DATE: January 13, 2021

<u>Certificate of Appropriateness Request:</u>	H-36-20
<u>Applicant:</u>	Monty and Carolyn Coggins
<u>Location of subject property:</u>	166 A Union St. N
<u>Staff Report prepared by:</u>	Katherine Godwin, Sr. Planner

CABIN'S FRONT PORCH

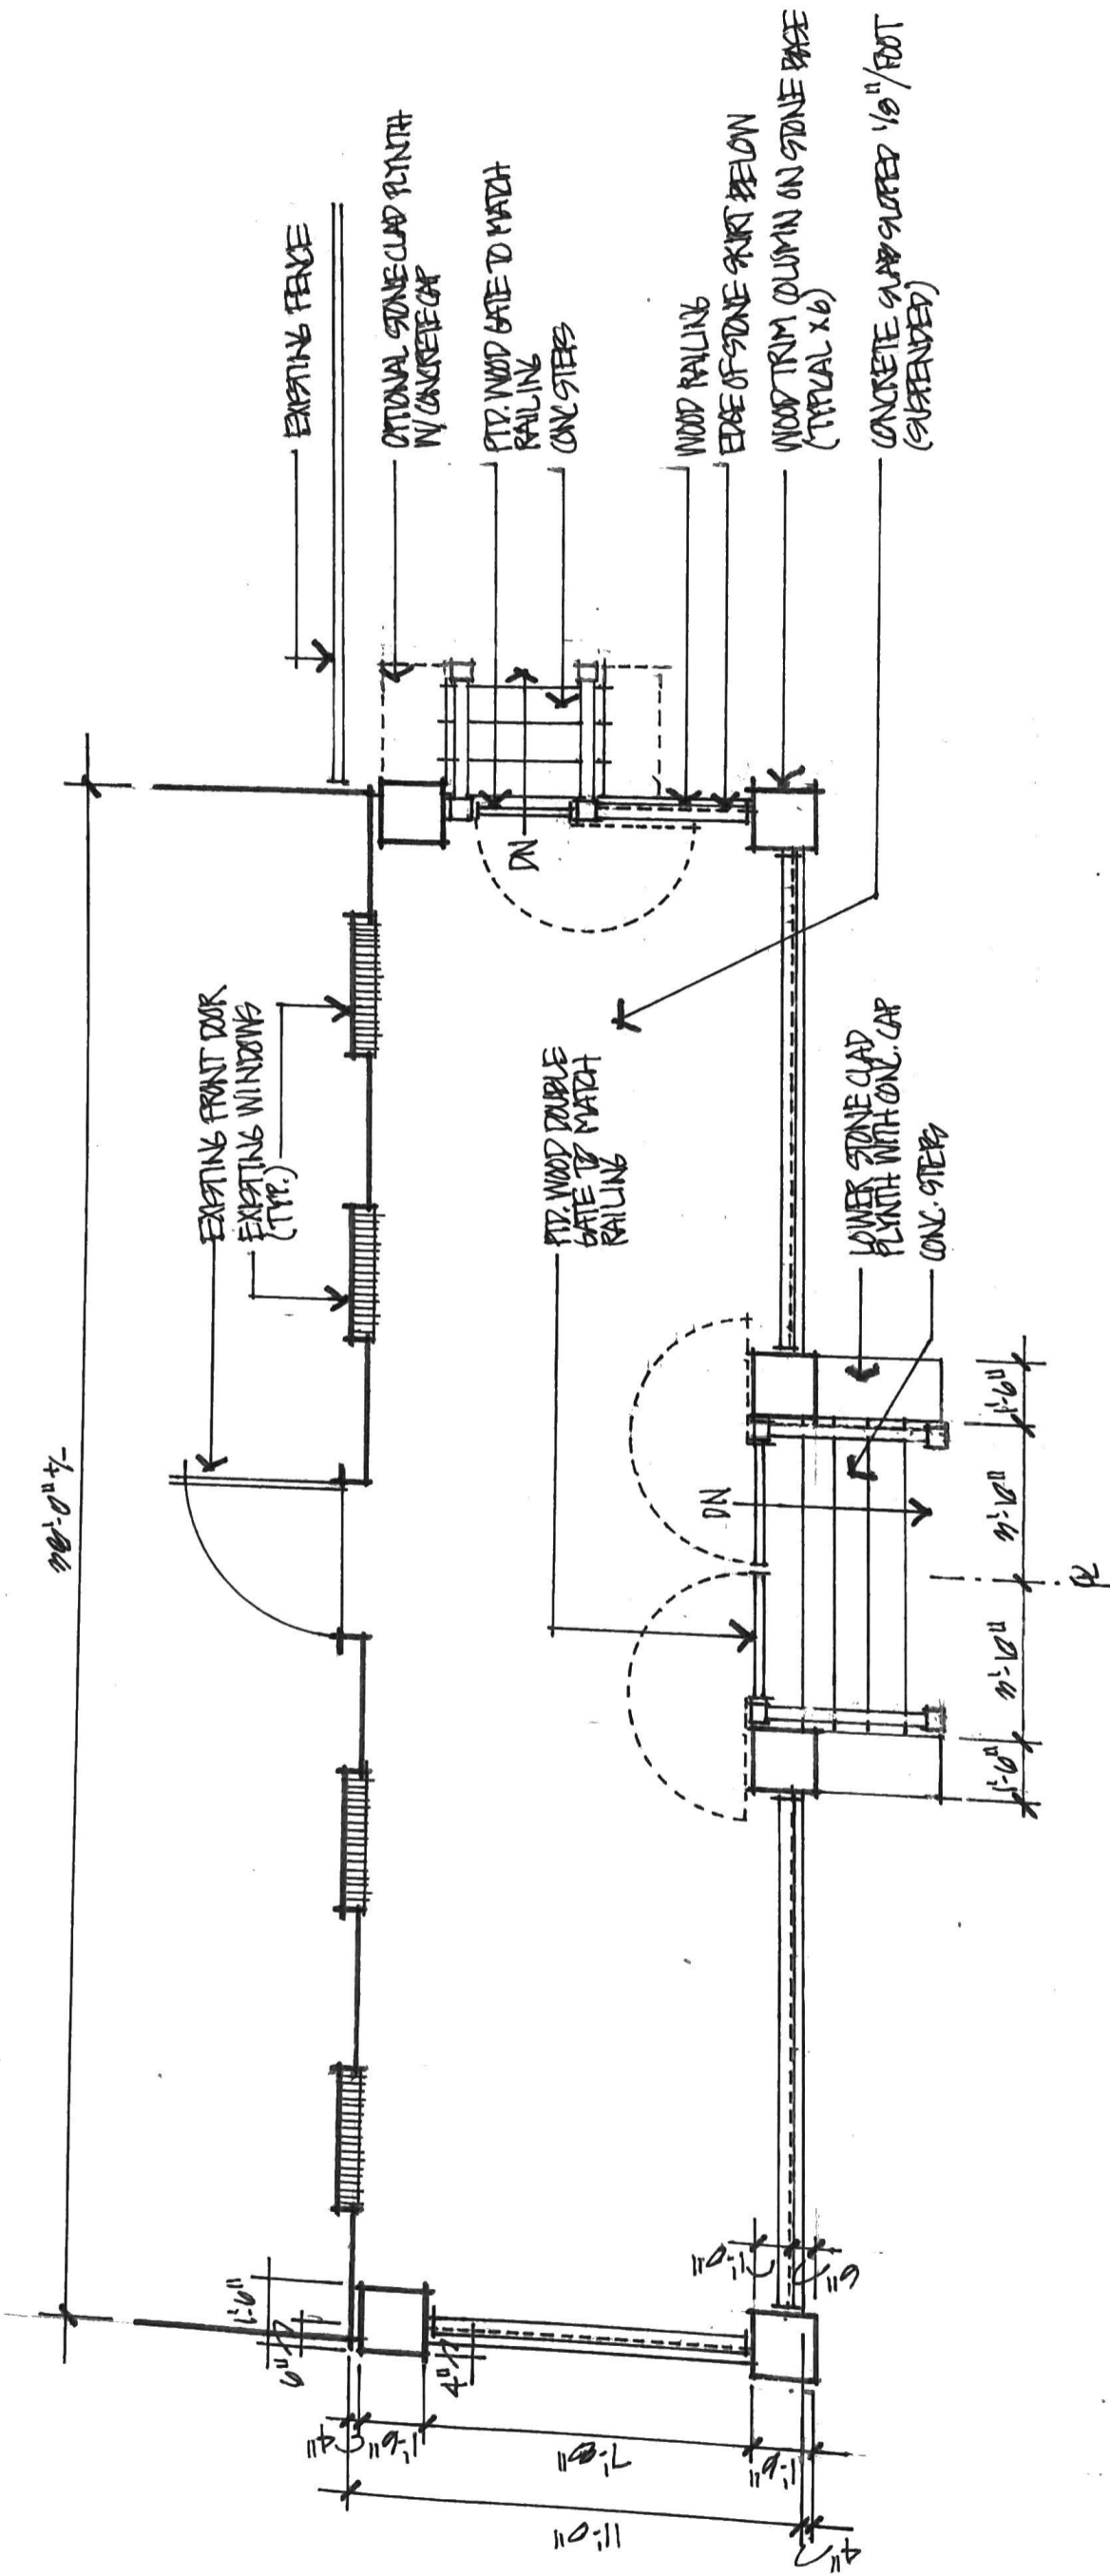
Note: Skirt and Column Base would be white brick not stone.

EXISTING FRONT PORCH
PORCH PLAN
SCALE = 1/4" = 1'-0"

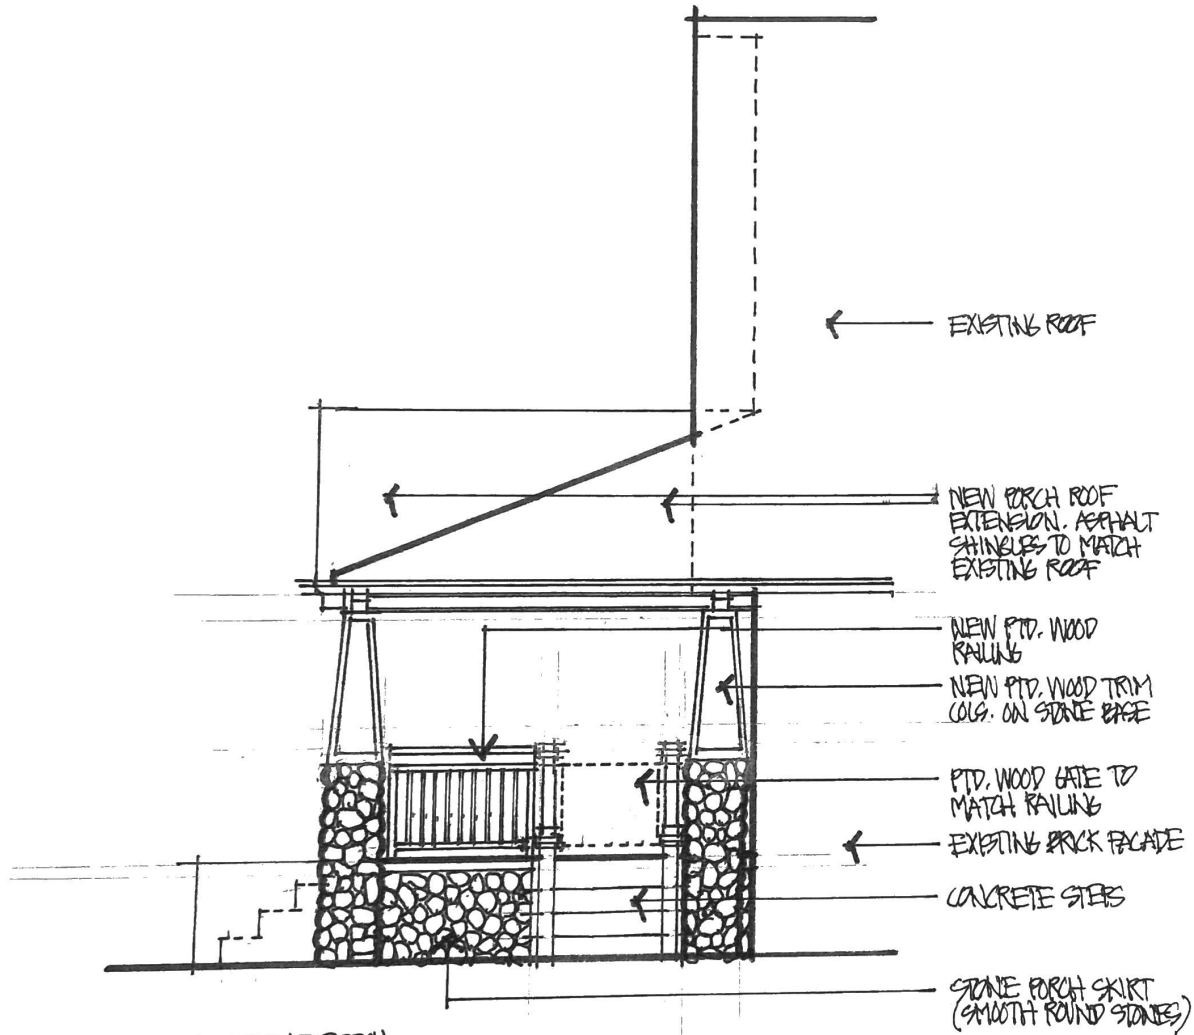
Note: Skirt and Column
Base would be white
brick not stone.

2. The existing stoop/porch- if I am interpreting your site plan correctly you are extending your front porch out as well as widening it. Are you planning on demolishing what is there currently or building on to it in terms of the flooring/roof/columns etc.? What are the current dimensions of the stoop/porch?
We are removing the current stoop (current dimensions 4 ft 2 inches deep and 9 ft 4 inches wide)

We are going to use brick instead of stone. The brick will match the white painted brick currently on the house.
